**ADDENDUM NO. 3**

**CITY OF PORTSMOUTH, NH**

**PROPOSED BRIDGE REPAIRS**

**MARKET STREET OVER TIDAL BASIN (NHDOT BRIDGE NOS. 240/106 & 241/106),  
KEARSARGE WAY OVER PAN AM RAILWAYS (NHDOT BRIDGE NO. 240/132),  
& RECREATION TRAIL OVER MARKET STREET (NHDOT BRIDGE NO. 220/143)**

Osprey Landing Site Access

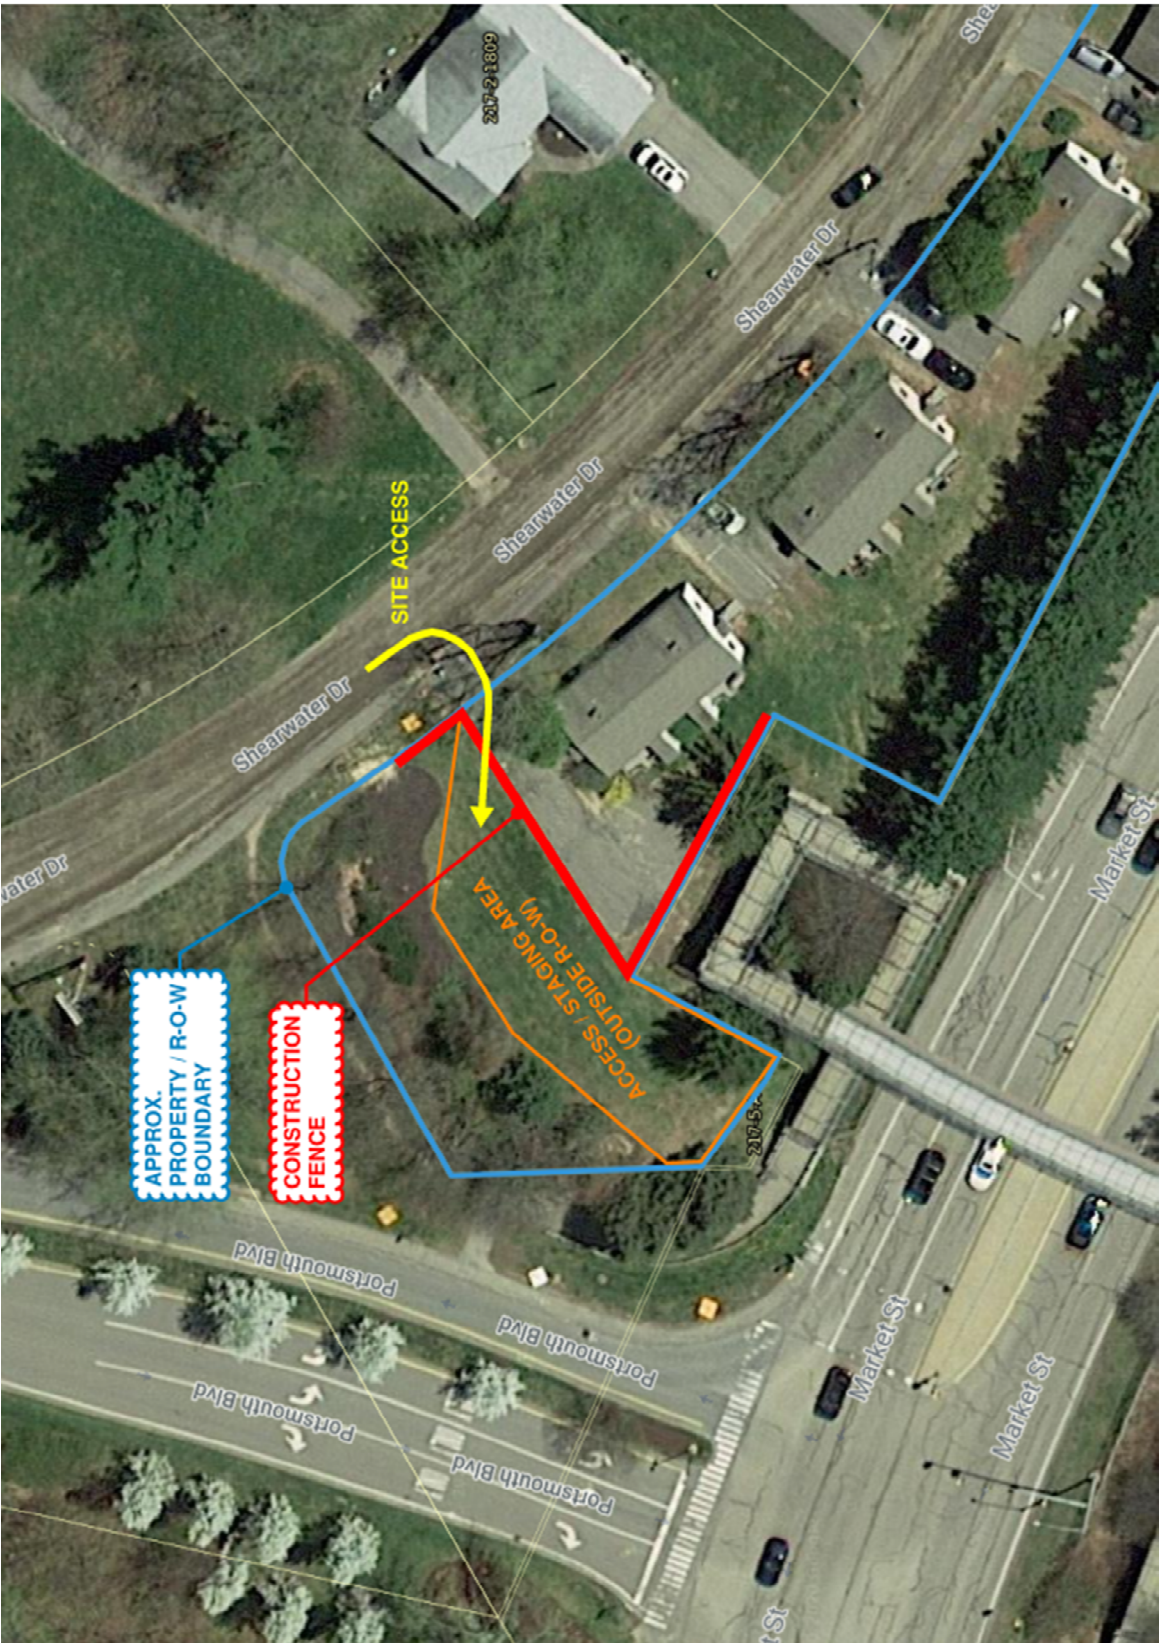
**Question #1:** Will the Contractor have access to the bridge from the Osprey Landing side?

*Yes, the project site will be accessible via the residential property located at 45 Shearwater Drive (the parcel abutting the bridge to the northeast). Conditions of the access across this property are currently being coordinated between the City and the property owner but are anticipated to include the following:*

- *The Contractor will be permitted to utilize the existing paved driveway at 45 Shearwater Drive to gain access to the lawn area north of the bridge, behind the landscape berm at the corner of Portsmouth Boulevard and Shearwater Drive. The intent of allowing limited use of the driveway, rather than accessing the area from Portsmouth Boulevard, is to avoid impacts to the established vegetation on the landscape berm.*

- *Driveway must remain unobstructed at all times for use by the 45 Shearwater Drive tenant, including the parking area at the rear of the structure near the southern building entrance.*

- *The Contractor shall install temporary construction fencing to delineate the storage area and ensure all storage and access does not encroach onto the driveway at 45 Shearwater Drive.*

- *All areas impacted by Contractor's operations shall be returned to existing condition, or better, upon completion of the work. This includes revegetating the lawn area, replacing damaged driveway or roadway pavement, replacing damaged landscape vegetation, etc.*

- *Contractor must coordinate with the 45 Shearwater Drive tenant regarding Contractor's proposed work schedule, equipment deliveries, etc., prior to commencing work.*

- *Contractor's sanitary facilities, as may be required by the contract, shall not be located on the 45 Shearwater Drive property.*

*The Contractor will be required to execute a three-party Memorandum of Understanding (MOU) with the City of Portsmouth and the property owner detailing the terms of the access agreement, when finalized. A graphic of the proposed site access is included on page ADDM-3.*
